December 4, 2002
NG-02-1106

Subject: Duane Arnold Energy Center
Docket No: 50-331
Op. License No: DPR-49
Single-Failure-Proof Status of Reactor Building Crane
Reference: NG-01-1428, dated December 21, 2001, from G. Van Middlesworth to NRC;
Single-Failure-Proof Status of Reactor Building Crane
File: A-101a, T-31, SPF-164

Additional Information Concerning the DAEC Reactor Building Crane

Portions of Calculations

DIAPHRAGM & VERTICAL STIFFENERS

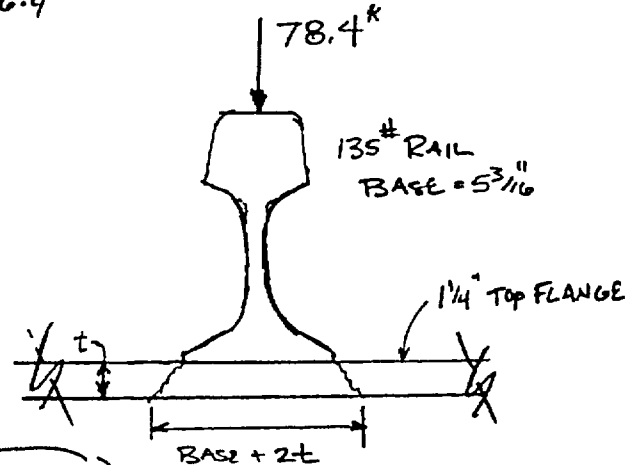
SPACING \leq 23.8" ACTUAL SPACING APPROX. 24"

OK, SINCE APPROX EQUAL BY ENGINEERING JUDGEMENT

NOTE: DIA. SPACING IS 24" MAX, MOST IS LESS.

THICKNESS UNDER = $\frac{386 - 375}{375} = 2.9\%$ DELETE Δ

3% OVER

SAY OK, SEE BELOW.

SAY OK SINCE BASED ON MAX. WHEEL LOADS & BEARING

STRESS IS $\frac{27.2}{40.5 \text{ ksi } \Delta} = 67\% \Delta$ of YIELD, JUDGED TO BE OK
 $\frac{27.2}{36} = 76\%$

Crane Girder Stiffener Spacing (Ref. 8)

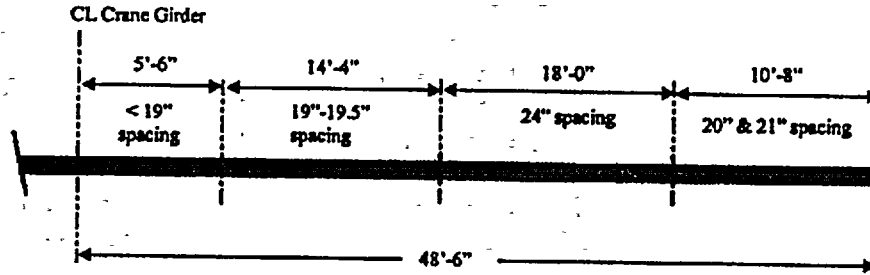
The calculation on page 16 shows that the required diaphragm stiffener spacing should be less than or equal to 23.83". Portions of the girder have a stiffener spacing of 24" as diagramed below, which is approximately 3/16" greater than allowed.

Since the stiffener spacing (center to center) can be equated with the "Beam Span" one can rationally substitute the "clear span" between stiffeners in the above formula. Deducting 1/2 of the stiffener plate thickness from each end of the center to center diaphragm spacing reduces the span to:

$$24" - 2(3/16") = 23.625" < 23.83" \quad \text{O.K.}$$

Therefore the 24" diaphragm spacing is judged adequate.
